ADDENDUM NO. TWO  
NCSB -FBMS

To the Plans and Specifications for:  
Nassau County School Board – Project No. 98110-031  
Fernandina Beach Middle School Kitchen / Dining Remodeling and Campus  
Renovations/Enhancements

Date: October 16, 2018

**M-5**

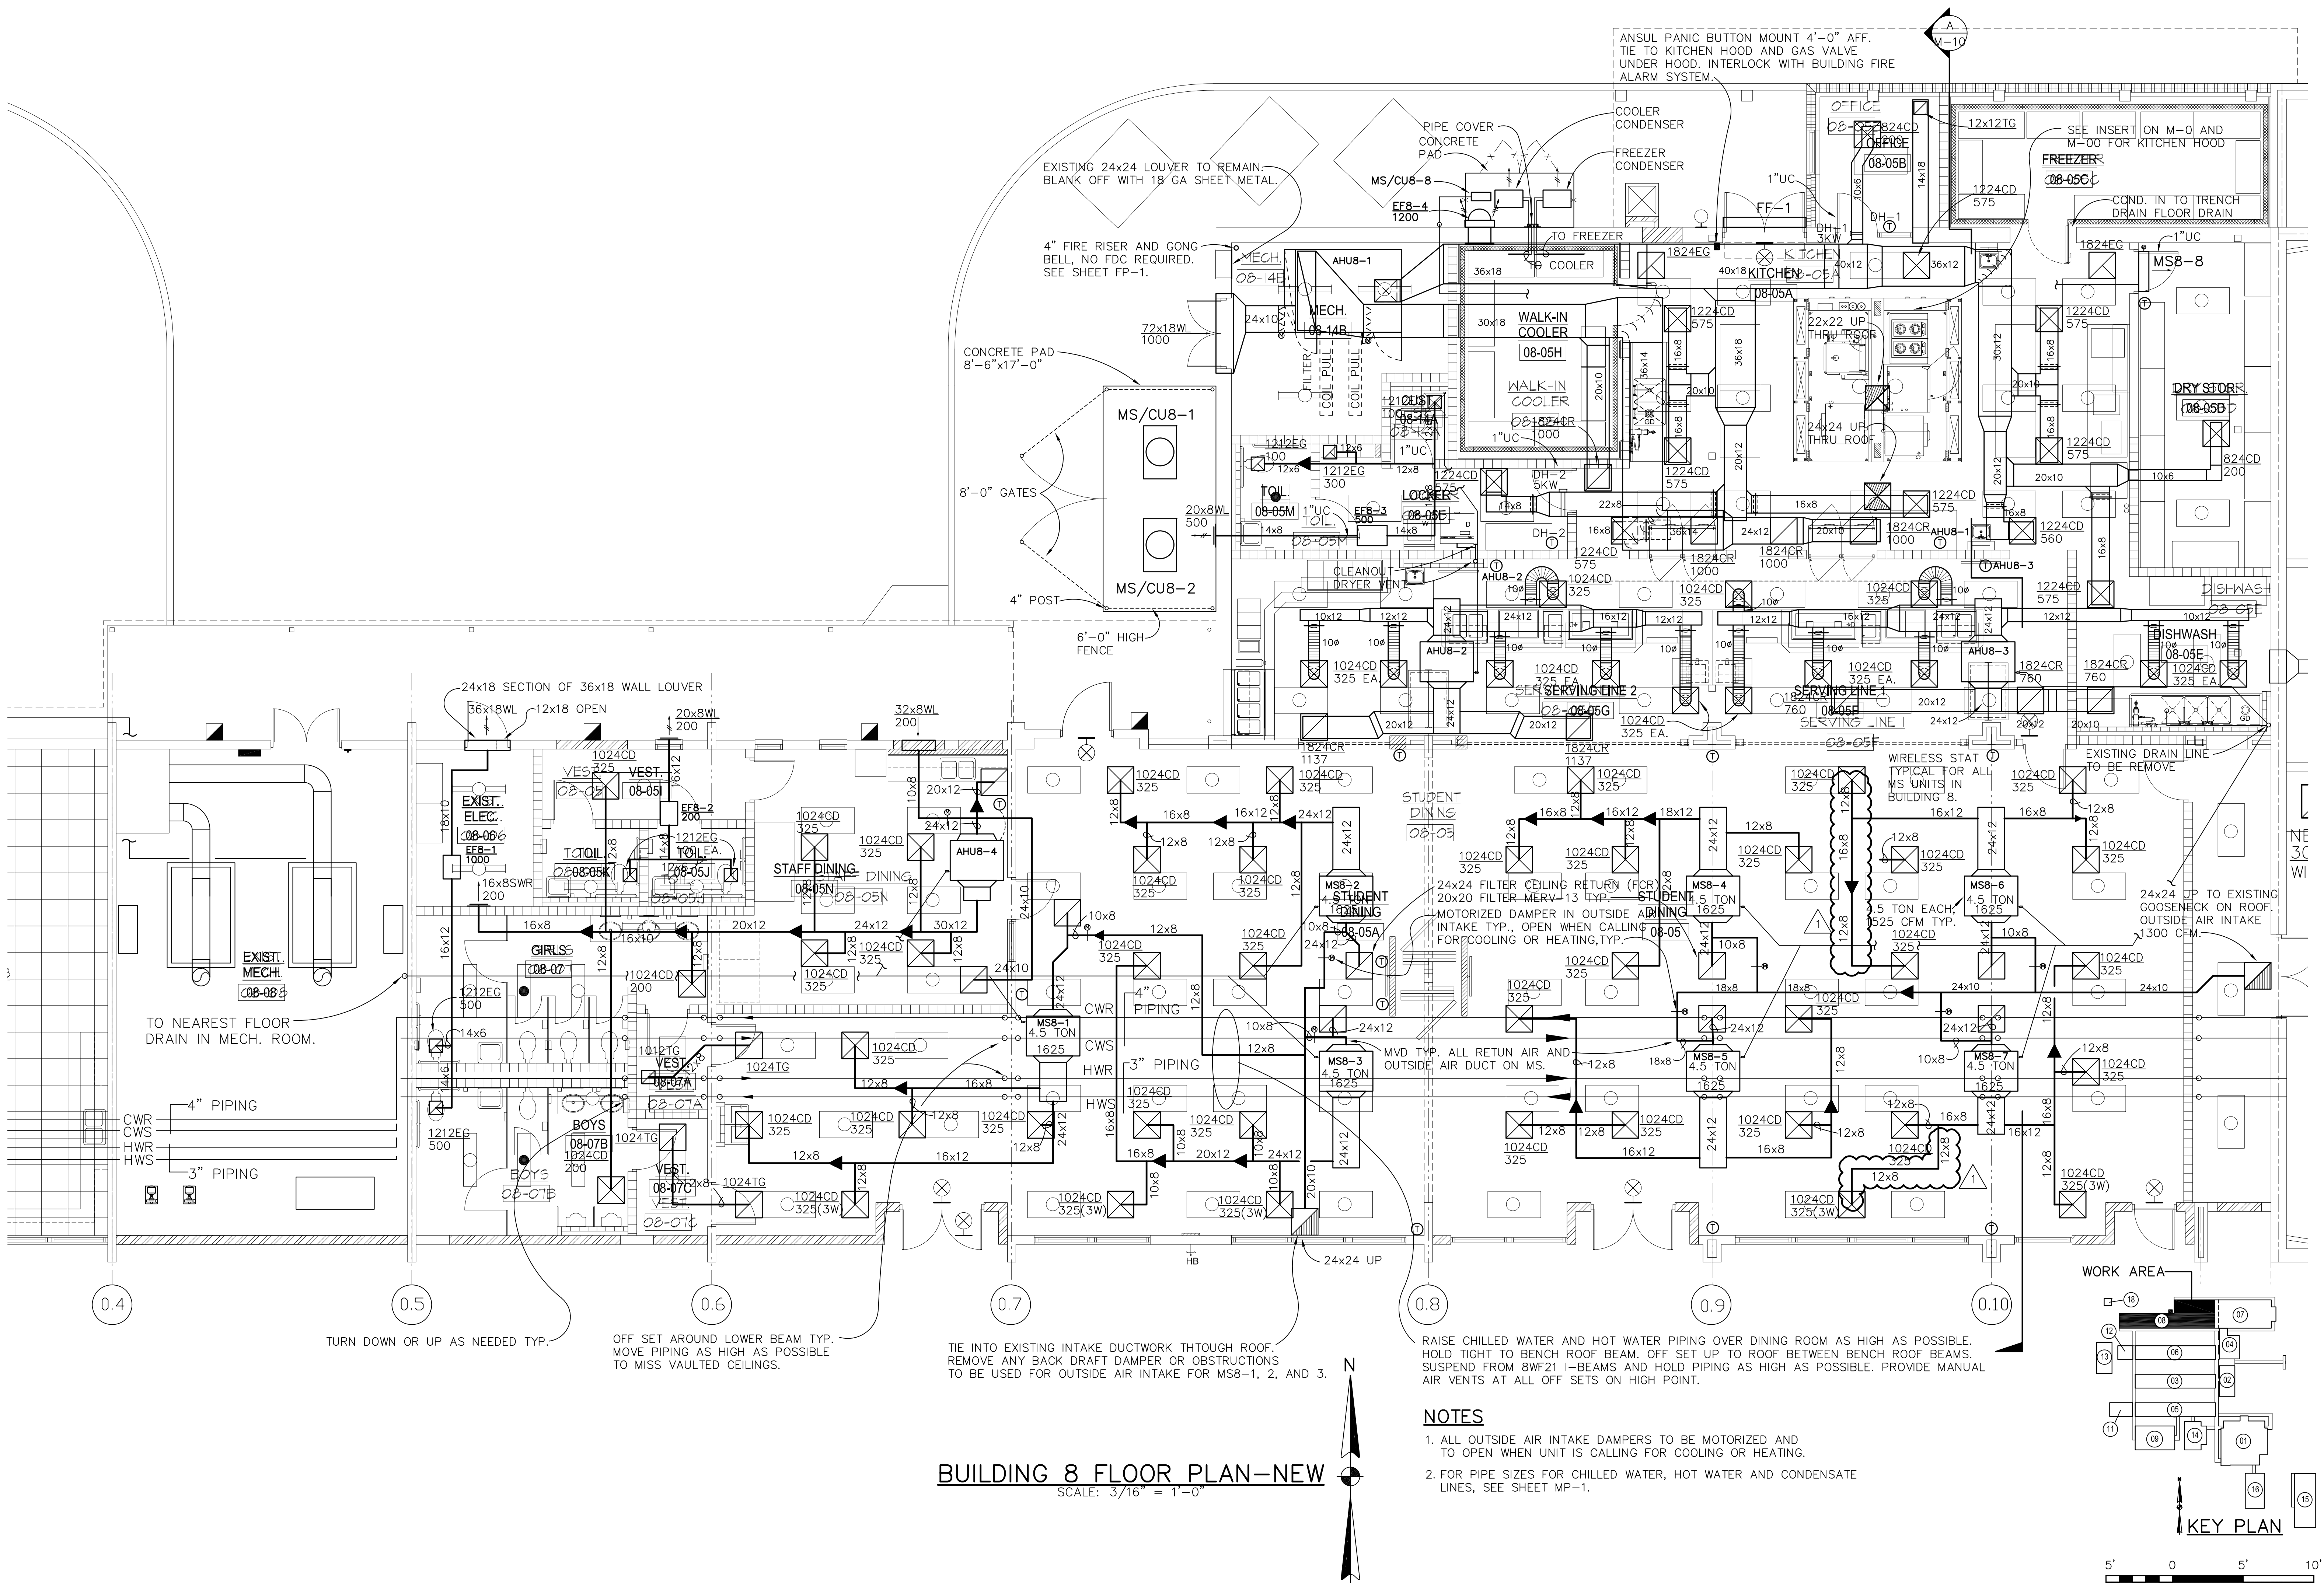
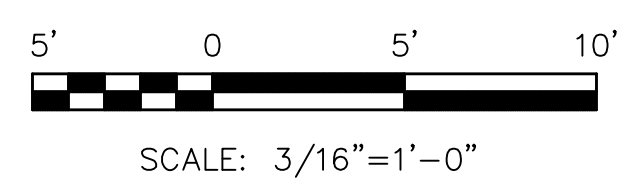
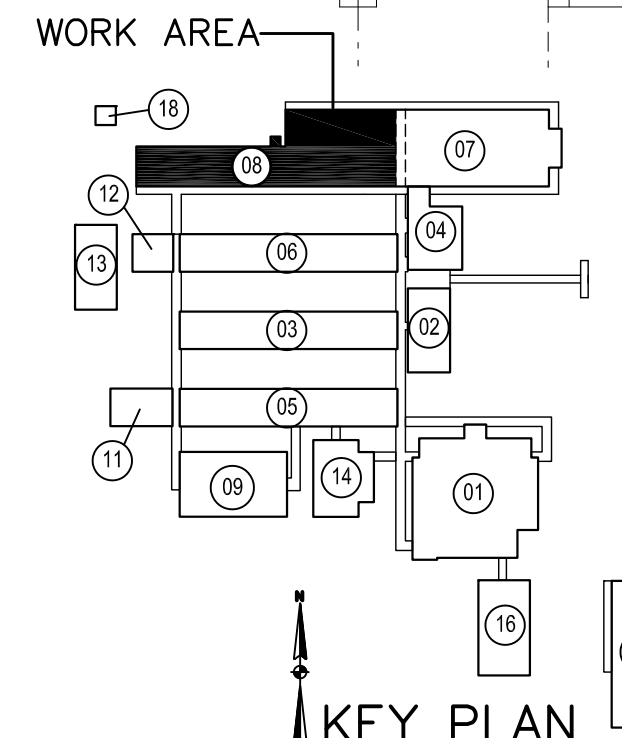
- a. Delete existing Drawing, M-5, dated 9/25/2018 and insert Drawing M-5, Dated 10/16/18.
- b. Added note, “Existing piping in rework area . . . To clear ductwork and new ceiling offset.

**M-7**

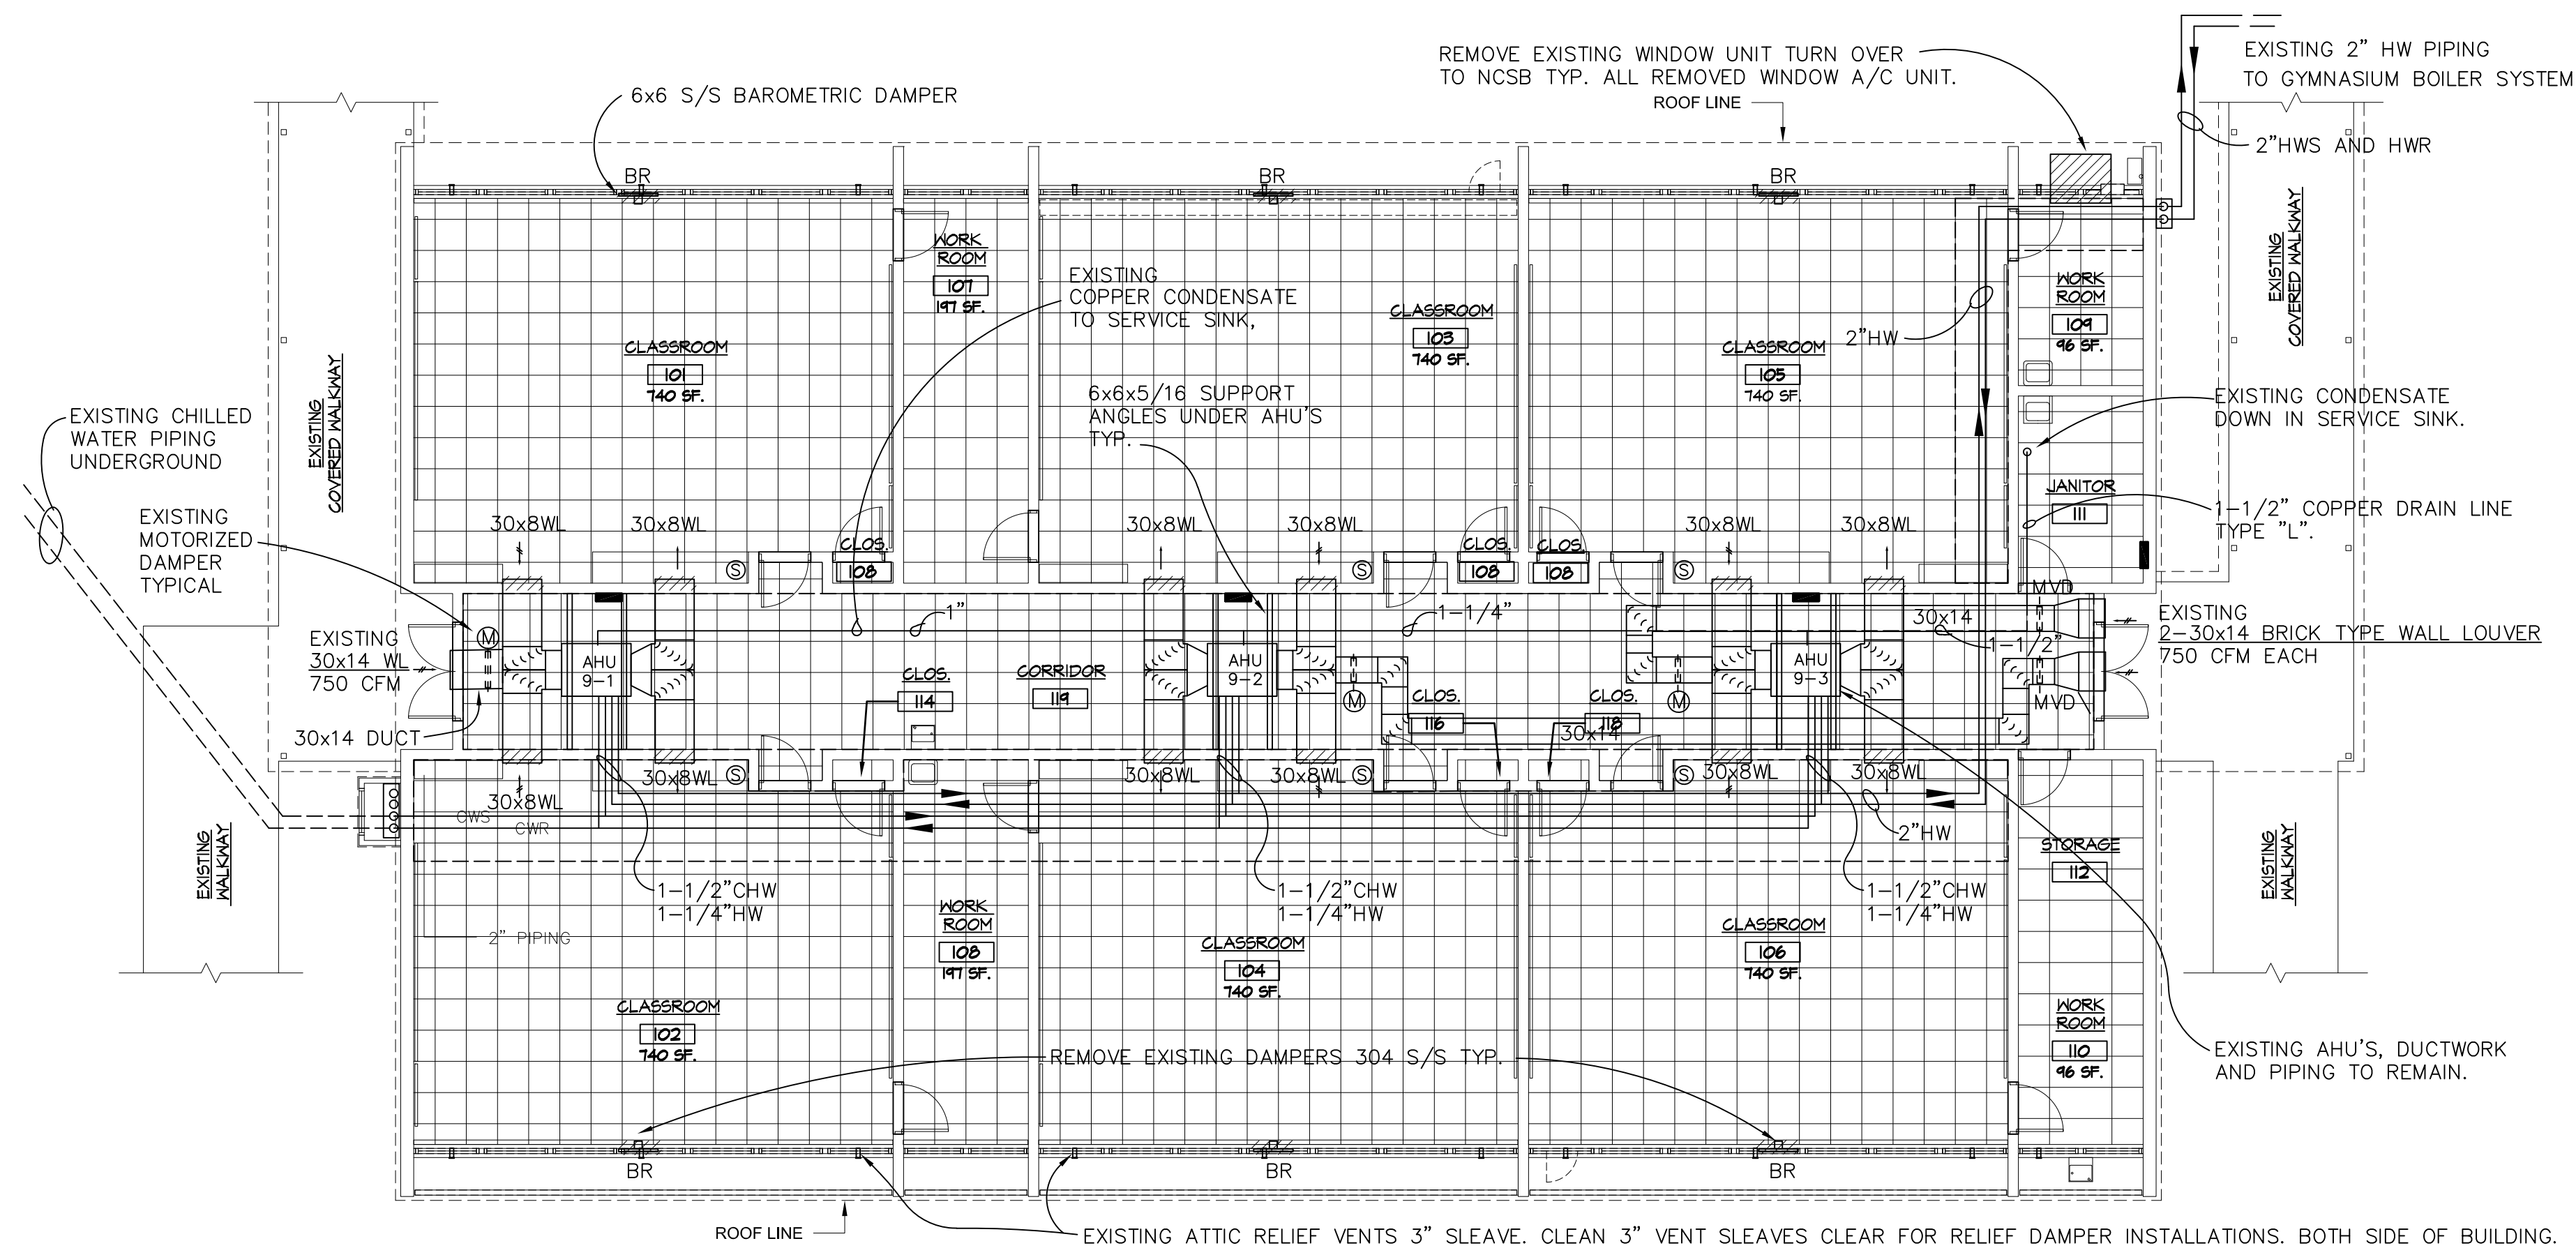
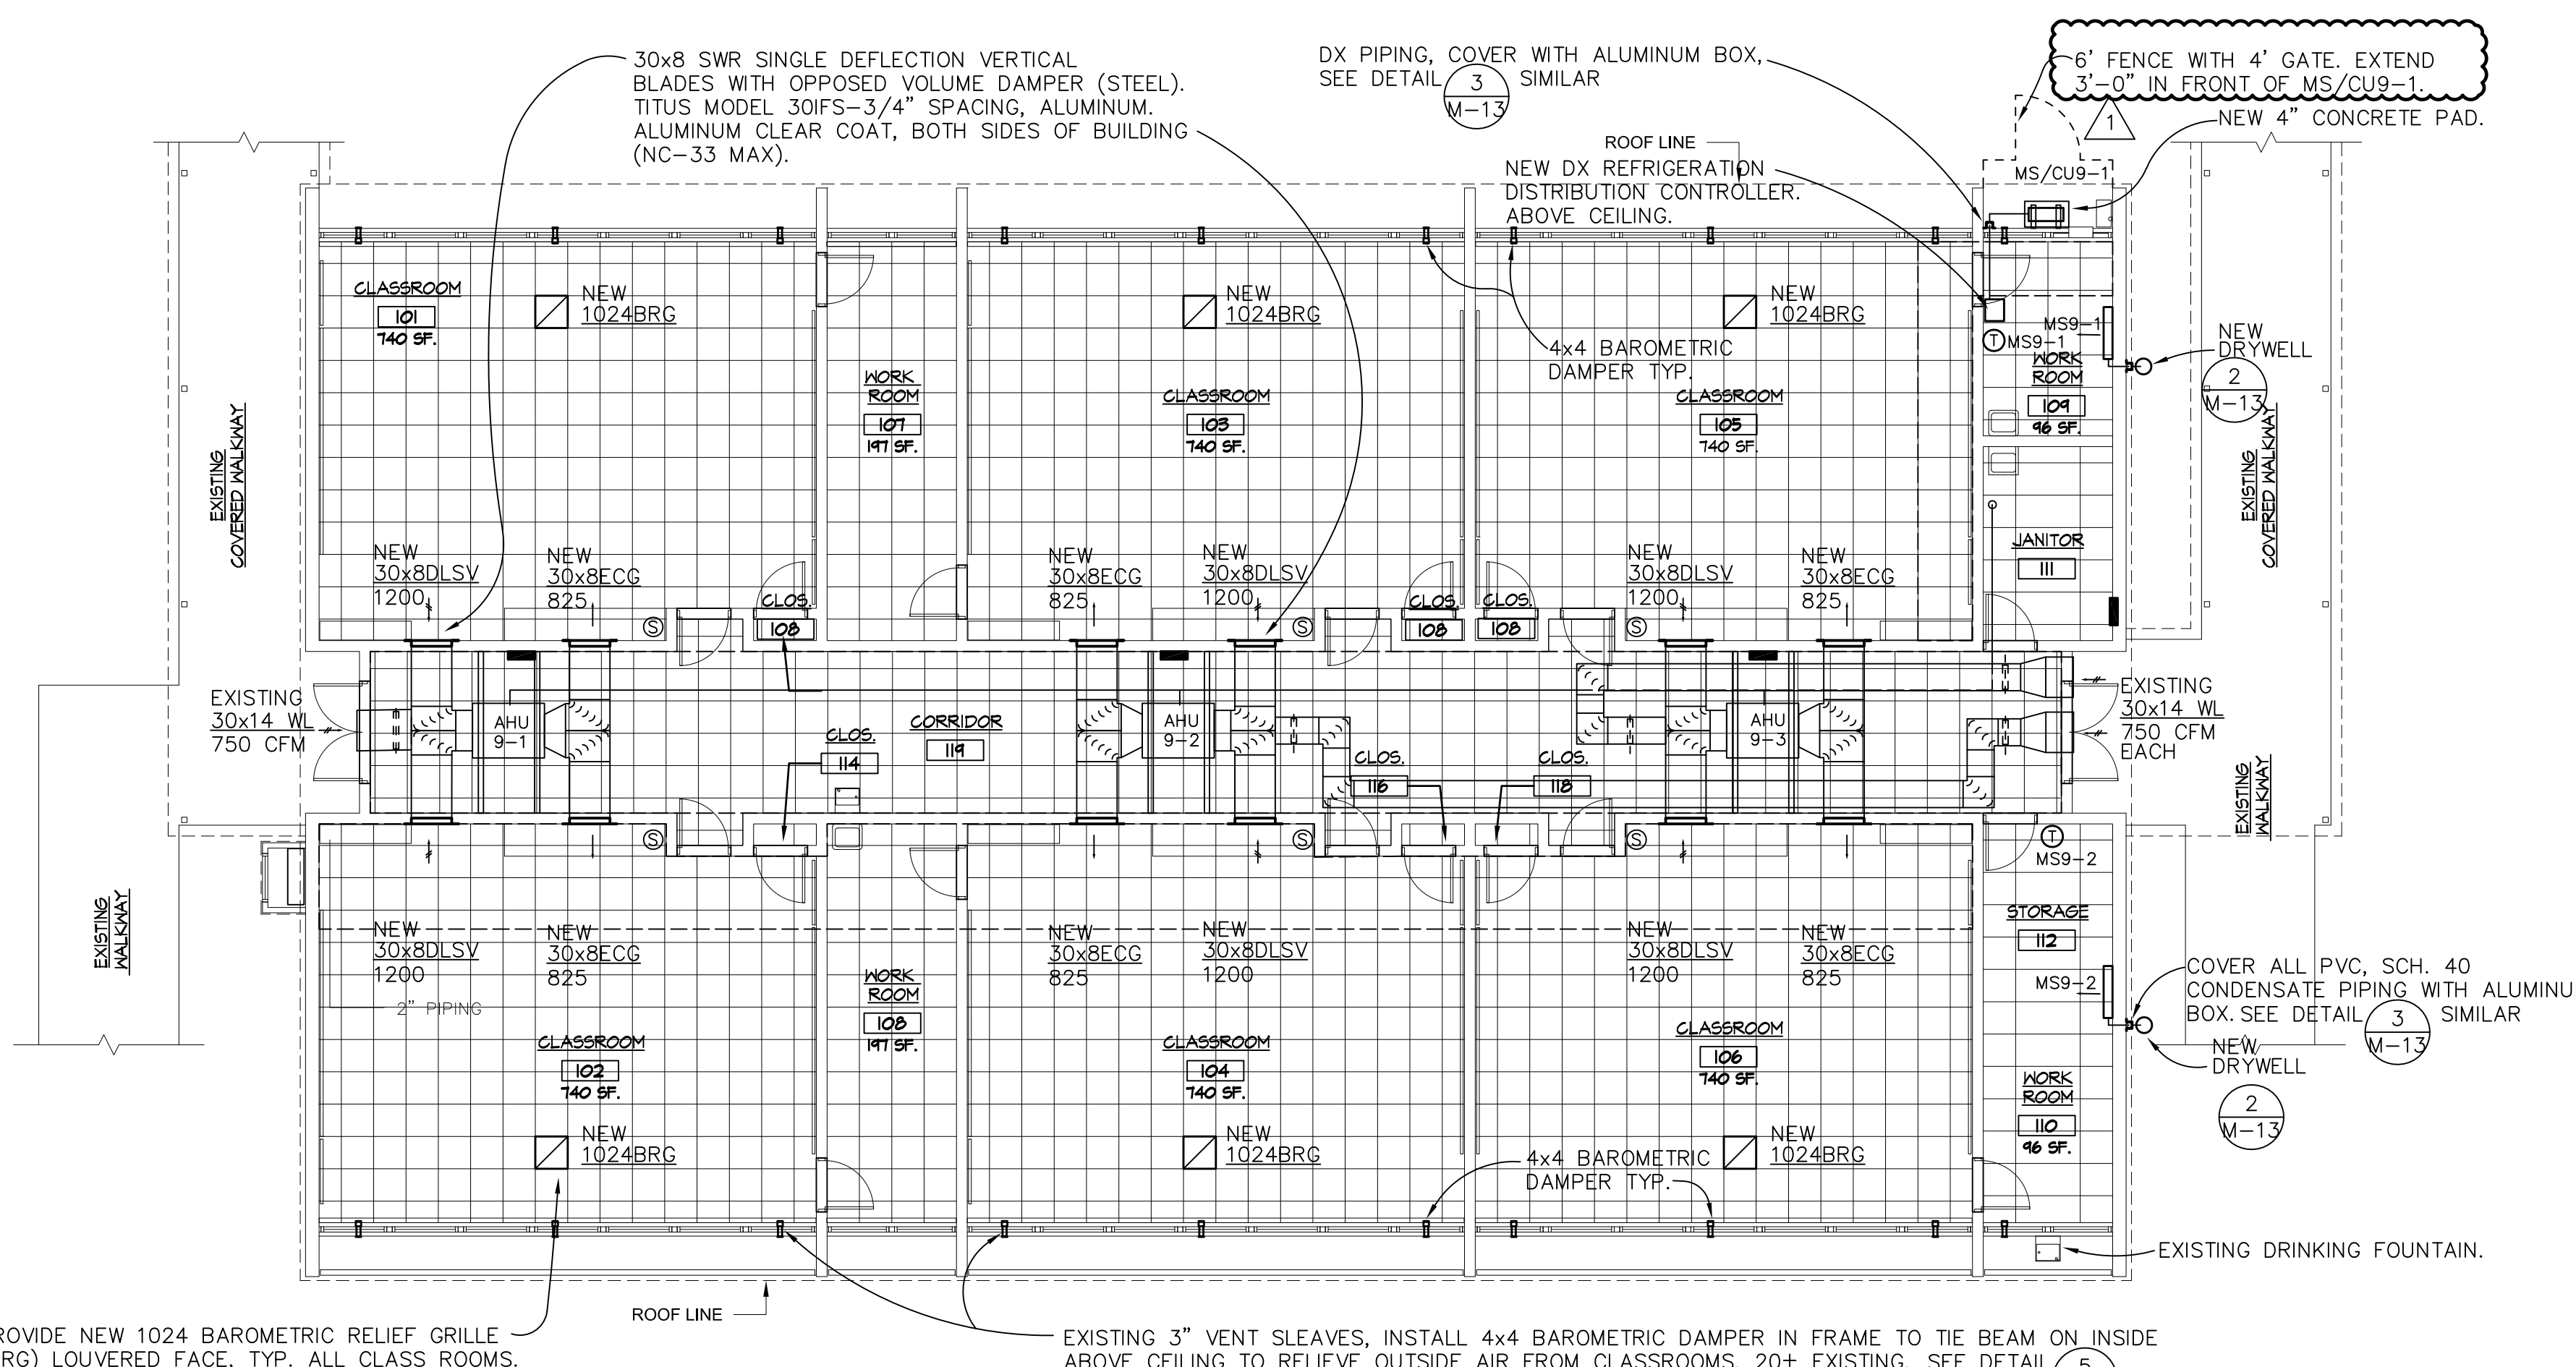
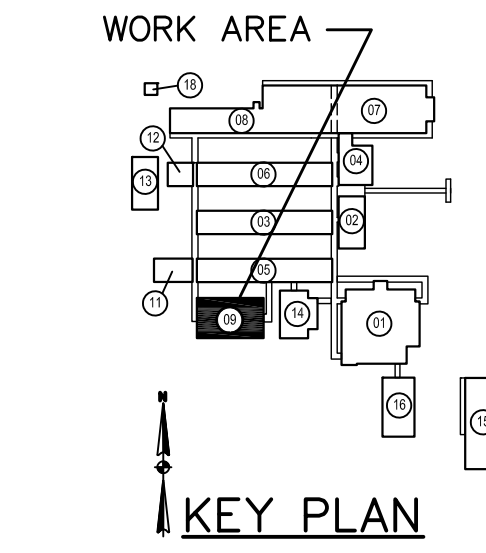
- a. Delete existing Drawing M-7, dated 9/25/2018 and insert Drawing M-7, dated 10/16/2018.
- b. Revise fence note outside of Room 109 new to read “6’ fence with 4’ gate extended 3’0” in front of MS/CU9-1.
